GLAC SERVICE INSTRUCTION #1

**GREAT LAKES**  
AIRCRAFT COMPANY

GLAC SERVICE BULLETIN #4

TAIL, REAR VIEW

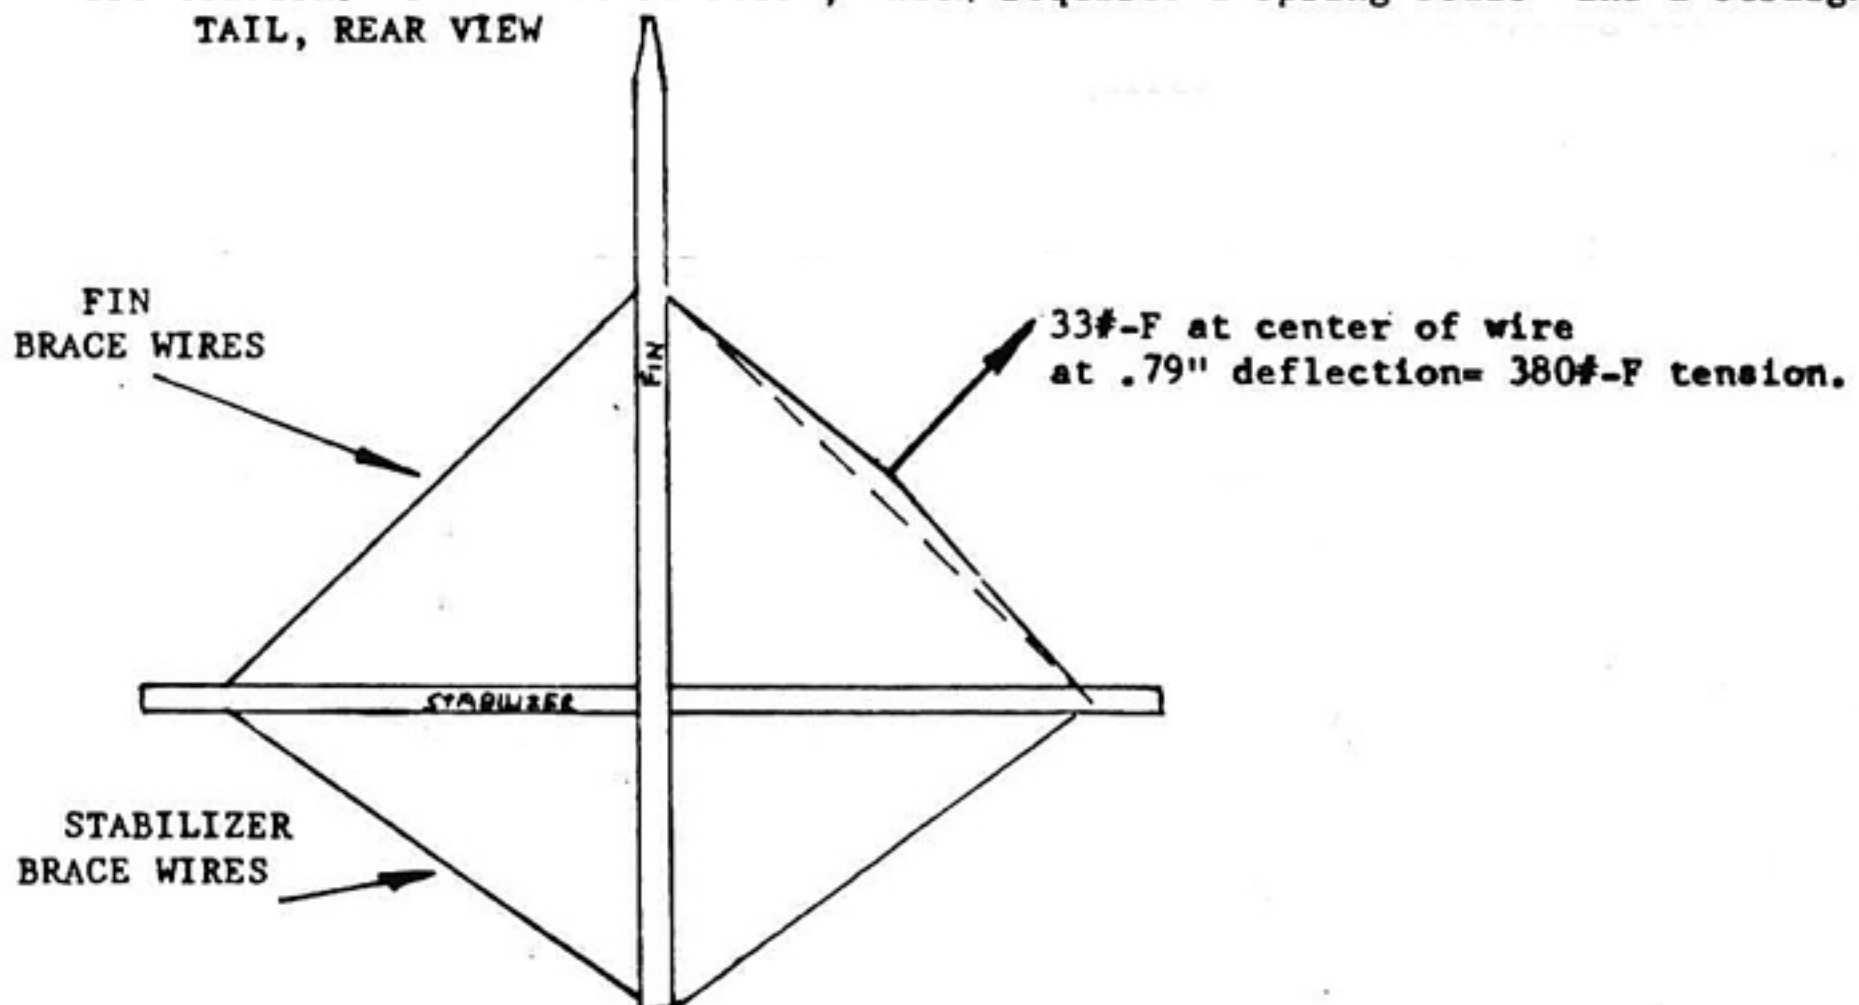
It has come to our attention that field adjustment of fin brace wires may cause different tensions between wires on the same side of the fin.

The proper procedure is as follows; With the stabilizer trimmed in the normal flight position, approximately centered, the bolt attaching wire lugs thru the stabilizer is tightened until lugs will not rotate, then backed off 3/4 turn --- this will allow lugs to "pivot" during flight trim adjustments.

The wires are then adjusted to the proper tension: 380 #,  $\pm 25$ .

Fin brace wire tension can be checked two ways: one, by using a flying wire tensiometer, which incorporates the deflection, and reads out directly in #-Force wire tension. Or the method below, which requires a spring scale and a straightedge.

GLAC SERVICE BULLETIN #4A

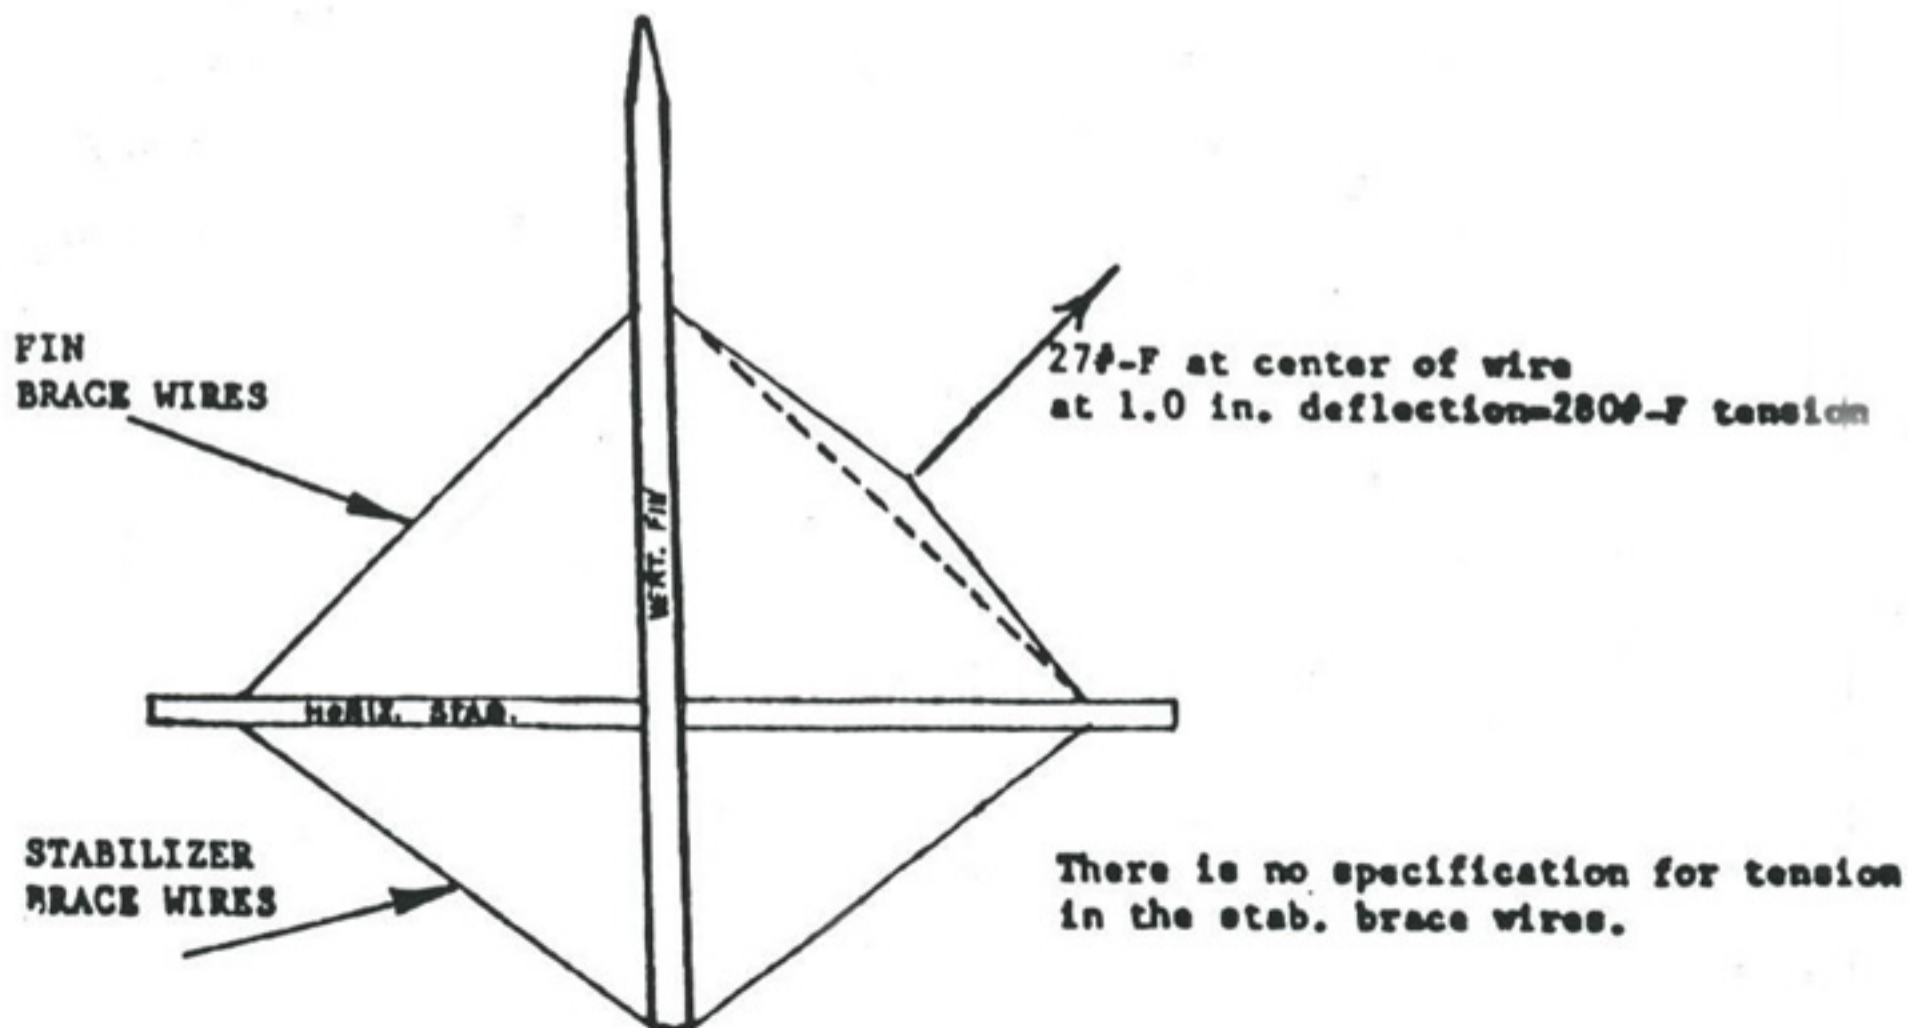
SUBJECT: CORRECTION OF SERVICE BULLETIN #4

PLEASE NOTE THE CORRECT TENSION IN THE FIN BRACE WIRE IS TO BE  $280\phi \pm 25$ .

Procedure: install all parts loosely, then tighten bolts through fin. Tighten all wires just until all slack is removed. With stabilizer centered, tighten the bolt through the stabilizer until the lug (10116-1) will not rotate, then back off the nut 3/4 turn. This will allow the lugs to pivot during trim adjustments. Progressively increase tension on all wires keeping elevator hinges perfectly in line; this may be checked with a string pulled taut. The lower wires adjust this, while the fin brace wires do more to move the fin itself. With the aircraft level laterally and longitudinally, the fin should be vertical (plumb).

Fin brace wire tension can be checked two ways: one, by using a flying wire tensionometer, which incorporates the deflection, and reads out directly in  $\phi$ -Force wire tension. Or the method below, which requires a spring scale and a straightedge.
